**Attachment 1 - PLN18/0183 - 19 Down Street Collingwood - Internal Urban Design comments  
(public realm only) (s57A plans)**

**TO:** Chris Stathis (Statutory Planning)  
**FROM:** Daniel Perrone (Urban Design)  
**DATE:** 06 Jan 2019  
**SUBJECT:** 19 Down Street, Collingwood  
**APPLICATION NO:** PLN18/0183

**DESCRIPTION:** Section 57a amendment to planning application pln18/0183. Key changes include a reduction in the scale of the proposed development from 14 to 8 storeys (plus basement levels), provision of upper level setbacks and changes to the materiality and massing of the development. The amendment results in a lesser car parking reduction being proposed. The amended proposal can be described as the construction of a building (8 storeys plus basement levels), including offices and ground floor food and drink (cafe) premises (permit not required for uses) and a reduction in the car parking requirements.

**To:** Chris Stathis  
**From:** Artemis Bacani  
**Date:** 4 December 2019  
**Subject:** Application No: PLN18/0183  
 Description: Multi-Storey Commercial Development  
 Site Address: 19 Down Street, Collingwood

Ground Floor Plan  
 Scale: 1:150 @ A3

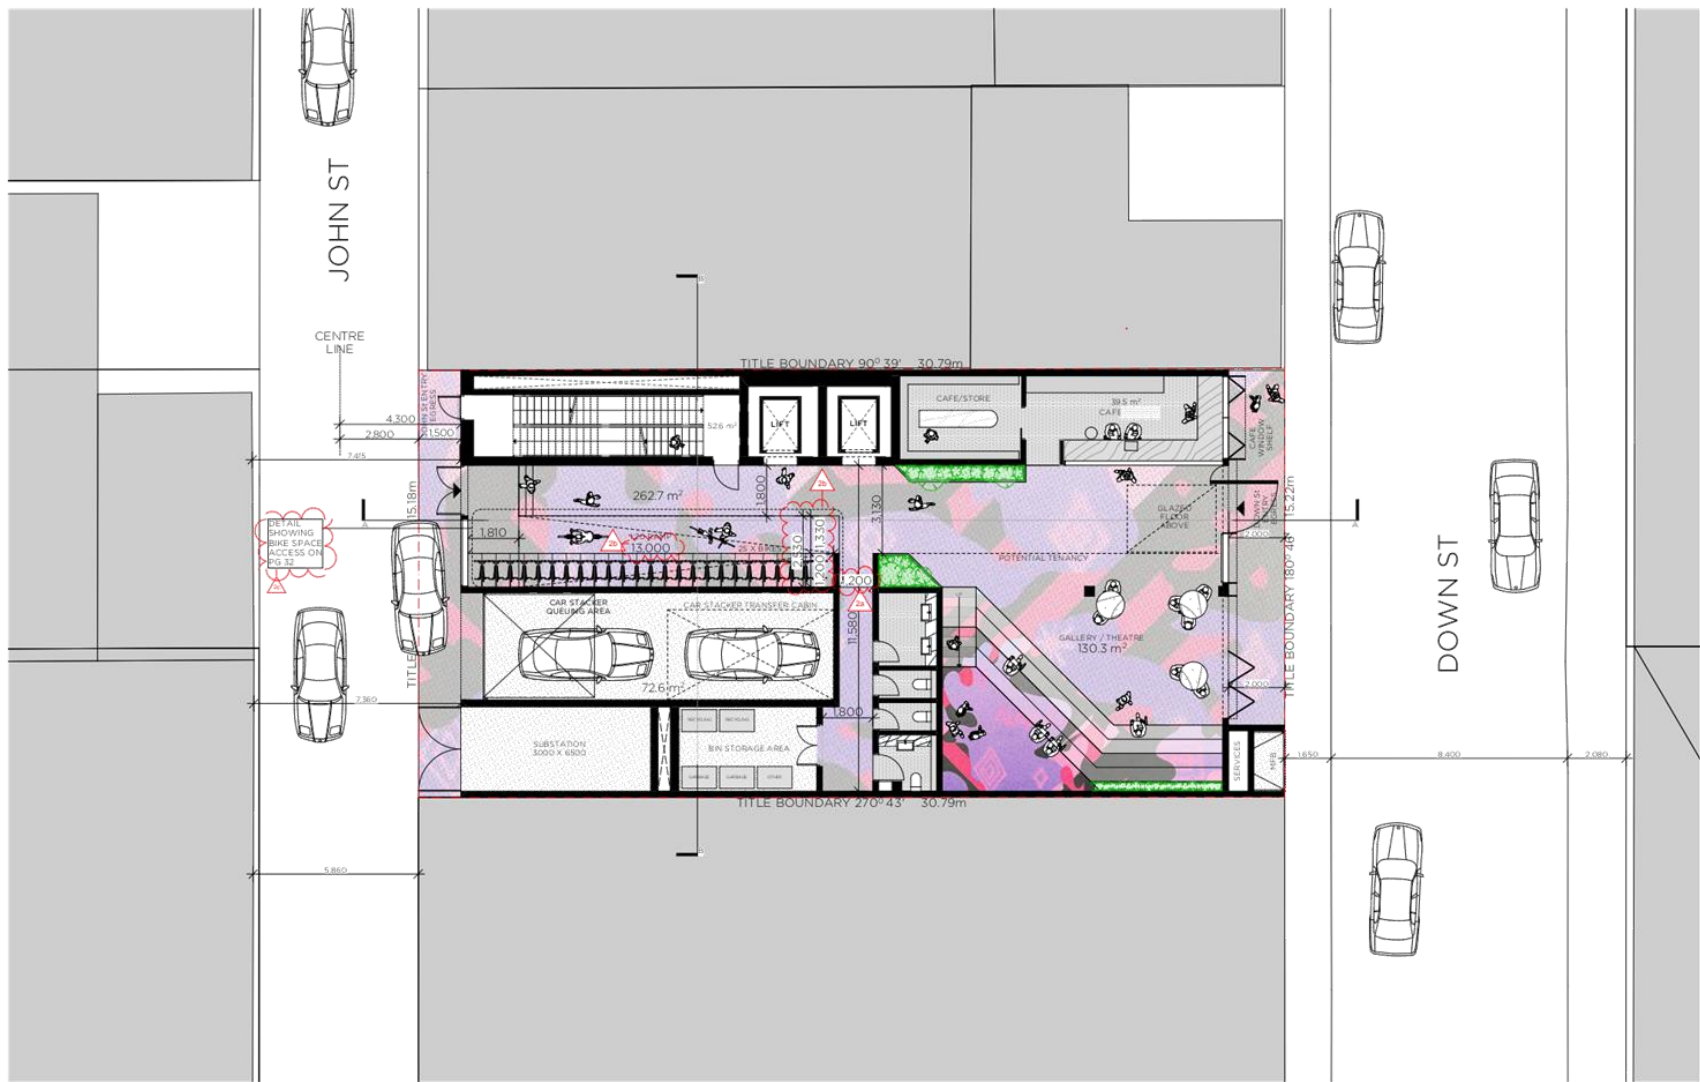
Item	Assessment
<b>Access Arrangements</b>	
Development Entrance – John Street Frontage	The width of the development's car park entrance is not dimensioned on the drawings.
Visibility	Convex mirrors are to be installed on either side of the car park entrance and are to be depicted on the drawings.
<b>Car Parking Stacker System</b>	
Car Stacker Device	All on-site parking would be contained within a fully automated car parking system, the Wöhr Multiparker 740. This model has a platform width of 2.2 metres and length of 5.25 metres to accommodate a B85 design vehicle.
Floor to Ceiling Height	The floor to ceiling height on the Ground Floor level has not been dimensioned on the drawings.
Vehicle Clearance Heights	The mechanical stacker device for this development provides a minimum height of 1.8 metres for at least 25 per cent of the total number of spaces to satisfy <i>Design standard 4 – Mechanical parking</i> .

Queuing Analysis	<p>Traffic Group has adopted a total service time of 145 seconds for a vehicle to access and be transferred to the parking within the system. With a service time of 145 seconds, the car stacker system is capable of servicing 25 vehicles per hour. For an inbound peak hour traffic volume of 7 vehicles per AM peak hour wishing to access the car stacker system, the utilisation ratio for the system (usage/capacity) would be 0.28 (7 vehicle trips per hour/25 vehicles per hour).</p> <p>To determine the storage queue of the car system, guidance is sought from the Australian/New Zealand Standard AS/NZS 2890.1:2004 and Austroads <i>Guide to Traffic Management Part 2: Traffic Theory</i> (Section 4.4 – Steady State Queues with Random Arrivals and Service). The mechanical device such as this car stacker system should have sufficient vehicle storage to accommodate the 98<sup>th</sup> percentile queue (the queue that will be exceeded on 2% of occasions). By knowing the utilisation ratio of the stacker (in this case, 0.28), the 98<sup>th</sup> percentile queue length can be calculated.</p> <p>Queue Length, <math>N = (\text{Log}_n \text{Pr}(n&gt;N) / \text{Log}_n \rho) - 1</math>  <math>\text{Pr}(n&gt;N) = \rho^{N+1}</math>                      where <math>\rho = r / s</math> (utilisation ratio)  <math>\rho = \text{average arrival rate} / \text{average service rate}</math>  <math>= 7 / 25</math>  <math>= 0.28</math></p> <p><math>N = (\text{Log}_n 0.02 / \text{Log}_n 0.28) - 1</math>  <math>= 2.07</math> car lengths, say 2 cars</p> <p>The 98<sup>th</sup> percentile queue length for the car stacker during the AM peak hour is two car lengths (including one vehicle in the transfer cabin). This means that one car would be in the queuing area.</p>
